REVISED PRELIMINARY PLAT
SOUTHERN RIDGE ADDITION
WICHITA, SEDGWICK COUNTY, KANSAS

RE: SUB 2002-55 -- Final Portion of Overall Preliminary Plat of Southern Ridge Addition

RE: SUB 2002-55 -- Revised Preliminary and Final Portion of Overall Preliminary Plat of Southern Ridge Addition

CASE NUMBER: SUB 2002-55 -- SOUTHERN RIDGE ADDITION

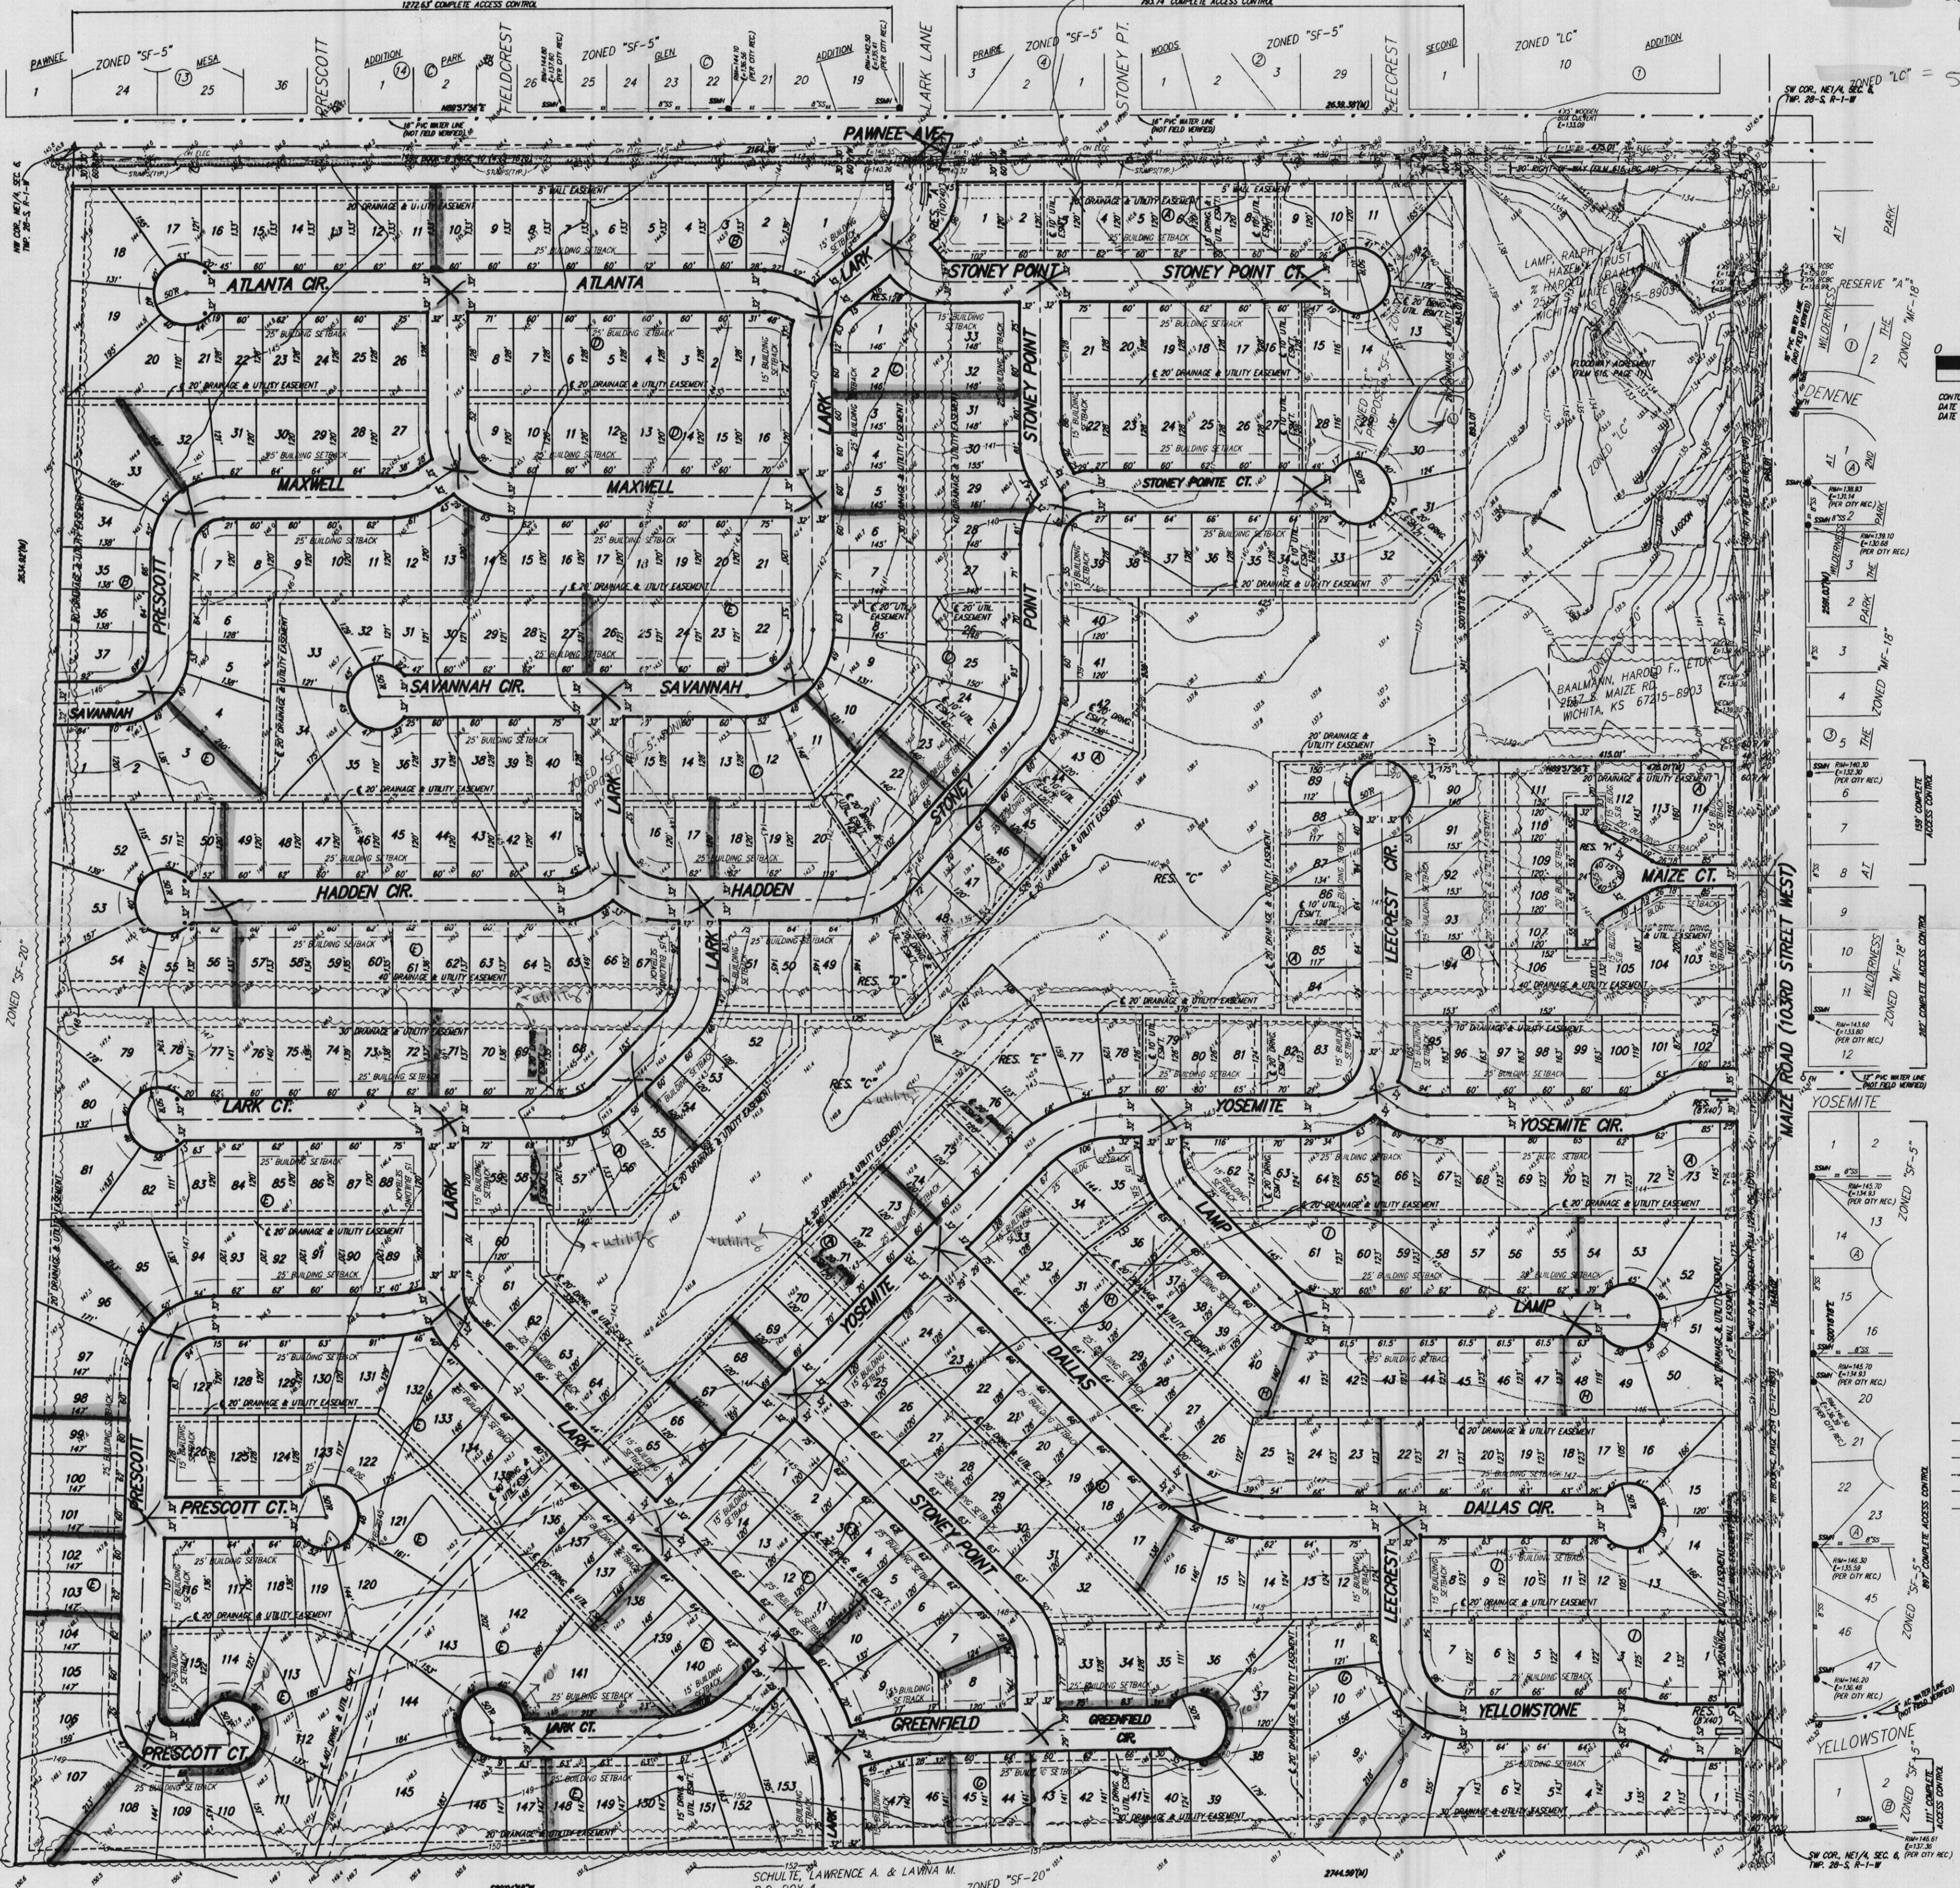
- D. City/County Engineering needs to comment on the status of the applicant's drainage plan. **An off-site drainage easement is needed. A drainage guarantee is needed. County Engineering has concerns regarding the amount of right-of-way in Pawnee that may be needed to pass the drainage past the plat from the west.**

- E. Traffic Engineering needs to comment on the need for any improvements to perimeter streets. **Left turn lanes at Pawnee and Maize are needed.**
- F. Traffic Engineering has requested the extension of Yosemite to Maize Road and a cul-de-sac for Lamp. **A left turn lane for Maize Ct is also needed.**

- G. The Applicant shall guarantee the paving of the proposed streets. The guarantee shall also provide for sidewalks on at least one side of all through, non cul-de-sac streets.
- H. It is recommended that Reserve C be extended to the street by access easements or by narrow strips of Reserve between the lots to increase its accessibility and usefulness for all homeowners in the Addition.

- I. Since Reserves D and E include a swimming pool, a site plan shall be submitted with the final plat tracing, for review and approval by the Planning Director. The site plan shall include the information indicated in the Subdivision Regulations. Otherwise a conditional use and public hearing will be needed in the future.

- M. The applicant shall guarantee the paving of the private street (Maize Ct) to a public street pavement standard. As private improvements, such guarantee shall not be provided through the use of a petition.

- N. A covenant shall be submitted regarding the private street, which sets forth ownership and maintenance responsibilities. The plat's text shall reference the platting of the reserve for private street purposes and shall state which specific lots are to be accessed by the reserve.

- O. The reserve being platted as private street shall be labeled as "private street".
- P. The wall easement shall be referenced in the plat's text.
- Q. The City Fire Department/GIS needs to comment on the plat's street names. **Revised street names are needed.**

- S. For any lots with existing tree rows that may be impacted by the installation of utilities, it is recommended that 30-ft utility easements be platted in order to allow for the installation of the utilities without damage to such tree rows.

- BB. The representatives from the utility companies should be prepared to comment on the need for any additional utility easements to be platted on this property. Westar Energy has requested additional easements.

Reserves D and E have been platted for additional access to Reserve C.
